IMPROVEMENT PERMIT / AUTHORIZATION TO CONSTRUCT / OPERATION PERMIT / EXISTING SYSTEM INSPECTION

PERMIT# 1100.39 PIN# ~~47110'6267.14~~ 491-13-7808 DATE 3/25/03

SUBDIVISION RIDGEWOOD BLOCK / SECTION ____ LOT 14 LOT AREA 1.66 AC SITE CLASS PS DESIGN FLOW 480GPD L.T.A.R. .36/.40/FT²

INITIAL SITE SKETCH 1"=50' OFF Septic

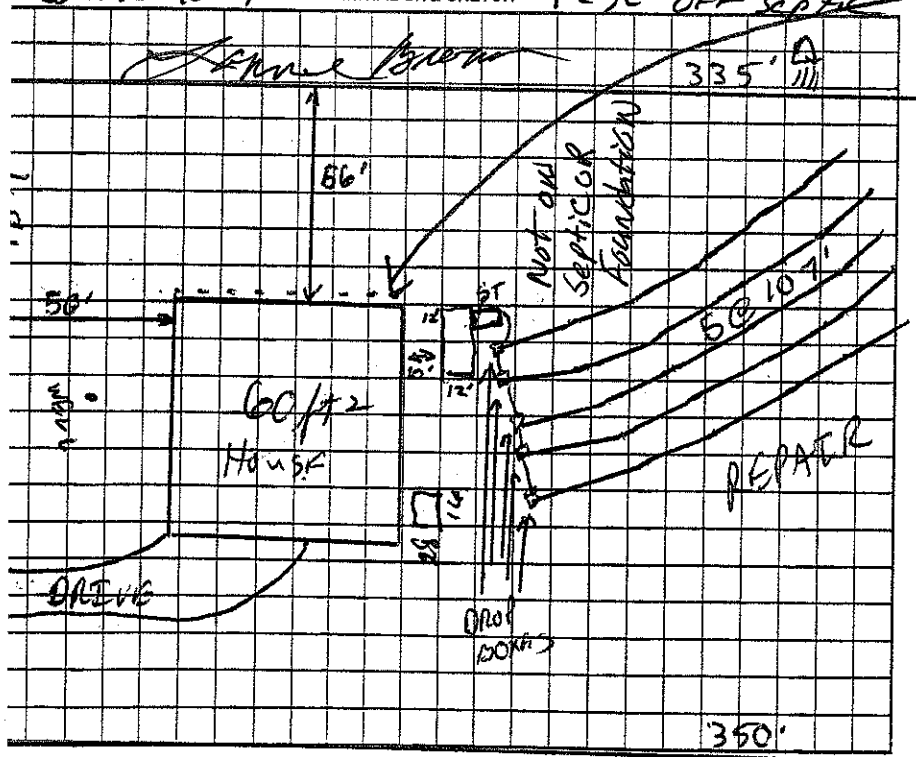
Comments:/Conditions: STAIRS OF PAVER Brick Patios

NO FOUNDATION PER OWNER

Pergola will be 5'+ OFF Septic & WATER Features will be 15'+

Comments:/Conditions: Approved 64'x60' HOUSE PLAN THAT IS 4 BEDROOMS ON 4-19-05. SIDE SETBACK IS CHANGED TO 62' NOT 106'. FRONT IS STILL 50' OFF ROAD

AS BUILT SKETCH

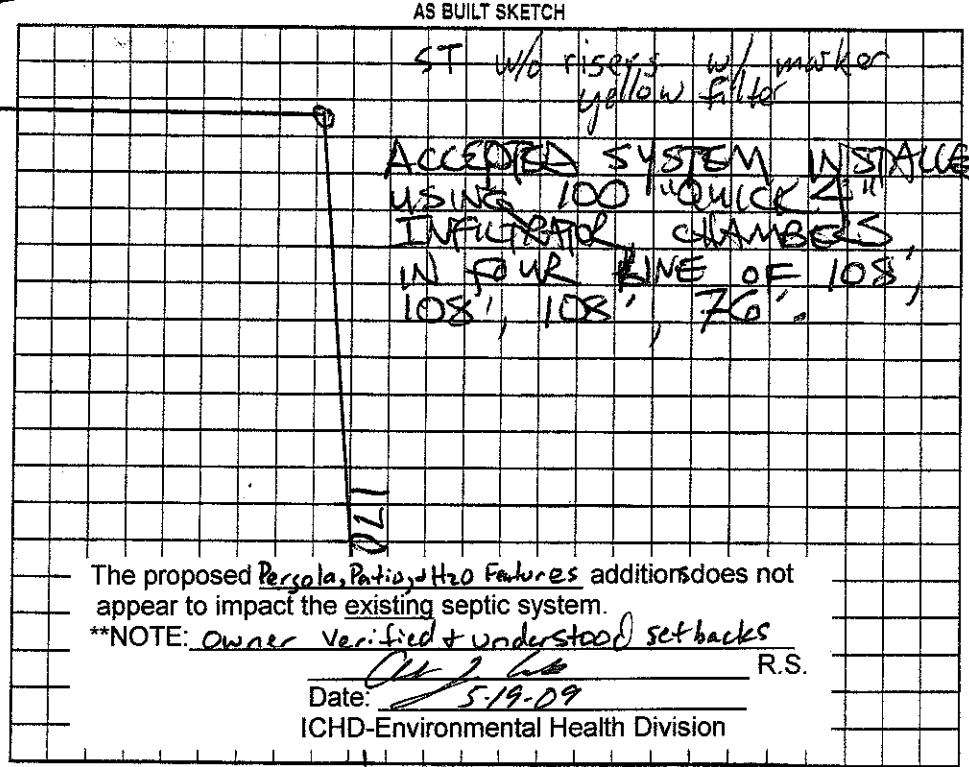
The proposed Pergola, Patio, H2O Features additions does not appear to impact the existing septic system.

**NOTE: Owner Verified + understood setbacks
